PLANNING BOARD AGENDA
MAY 18, 2016 – 7:00 P.M.

RESPONSE TO COMMENTS PAT CLEARY DATED APRIL 13, 2016
ROONEY, 17 MILLER ROAD, TM # 86.11-1-18

**Re: Lake Plaza Shopping Center
983-1005 Route 6,
Mahopac, NY 10541
Tax Map #65.10-1-45 & 46 – Site Plan Review**

To: Carmel Planning Board
From: Richard J. Franzetti P.E. Town Engineer
Date: January 8, 2016
Re: Lake Plaza – Amended Site Plan 65.10-1-45 and 46

EXISTING CONDITIONS
SCALE: 1" = 30'

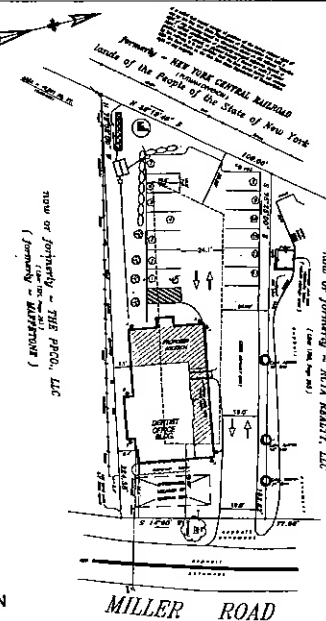
4. Parking space 8 is the existing condition. Parking space 13 is the proposed condition. The parking area is to be restriped. 24 feet is provided between the edge of parking space 13 and the edge of the building. An existing condition plan has been provided.
